**BEFORE THE PORIRUA CITY COUNCIL
AND GREATER WELLINGTON REGIONAL COUNCIL**

AND JAGGER NZ LIMITED
Applicant

**STATEMENT OF EVIDENCE OF KYLE JOHN CHRISTENSEN ON
BEHALF OF THE APPLICANT**

2. I have been engaged by the Applicant to provide expert advice on flood and erosion hazard management for the proposed Brookside development adjacent to the northern most reach of Duck Creek which is located in the Porirua suburb of Whitby.

Figure 1 - Reach 1 Upstream of Site (Samuel Marsden)

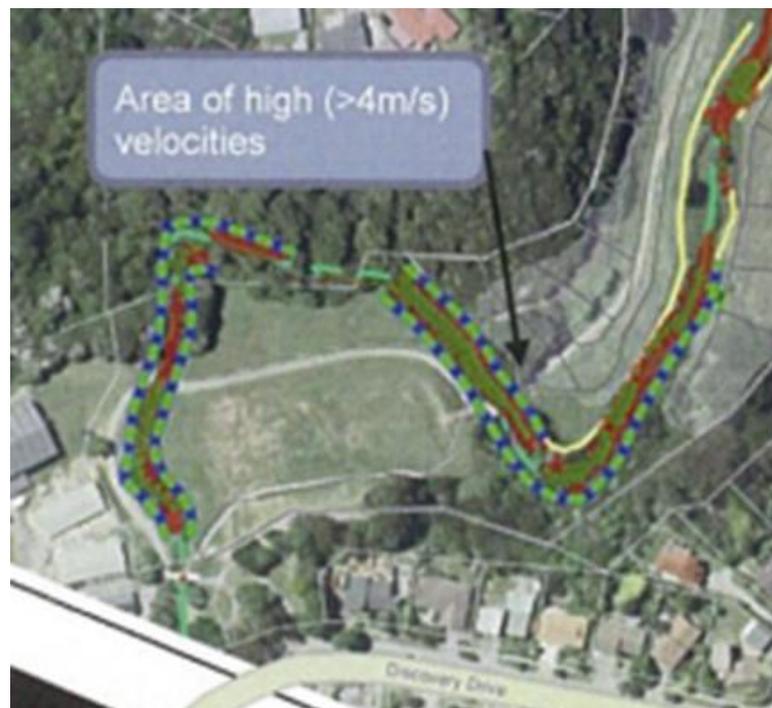
18. Mr Joseph has recommended rock lining almost this entire reach. I do not consider this appropriate or necessary. Firstly, the majority of this reach is outside the property boundary of the proposed development and is not being affected by the proposed works. Secondly there is mature vegetation on both sides of the channel in this reach and inspection of aerial photographs from 2002 suggests it has been stable for at least the past decade. Mr Joseph has also extended the rock proposed by Cardno on the right bank, near the downstream end of the reach, to extend all the way back to the bend. I do not consider this extent of rock is necessary in what is a straight and relatively stable reach of the creek.

Figure 4 – Reach 4 Between Bridges Nr.1 and Nr.3

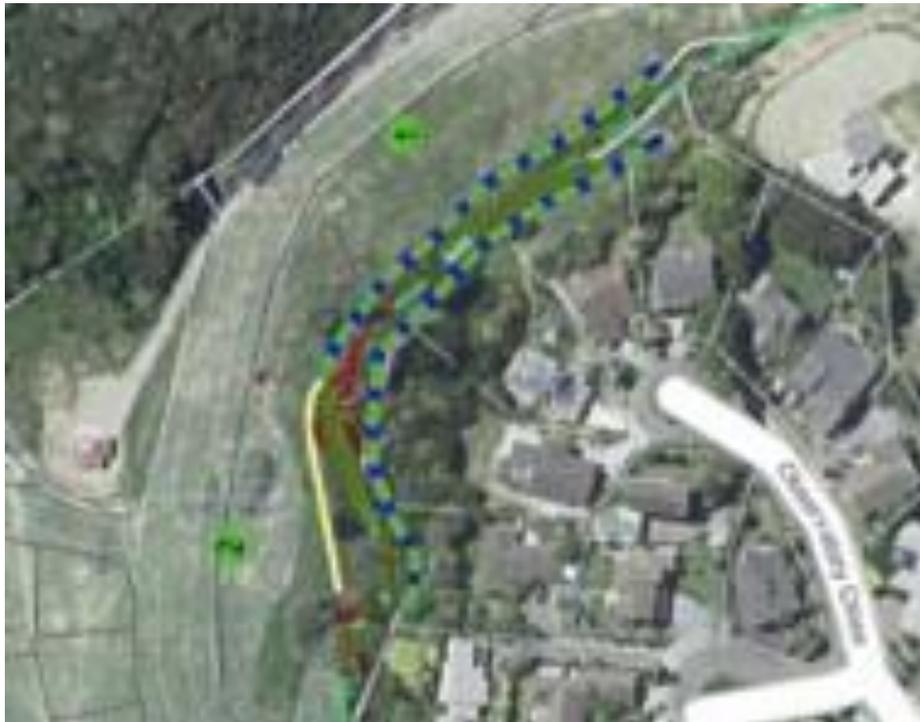
21. Mr Joseph has recommended rock lining most of this reach. Similar to the reach immediately upstream there is mature vegetation through much of this reach and the extension of the proposed riparian restoration and planting through this reach will provide some additional protection. It is also noted that this is a relatively straight and stable reach of the creek and that engineered vegetative cover is provided in the current Cardno design to protect the earthworks batter.
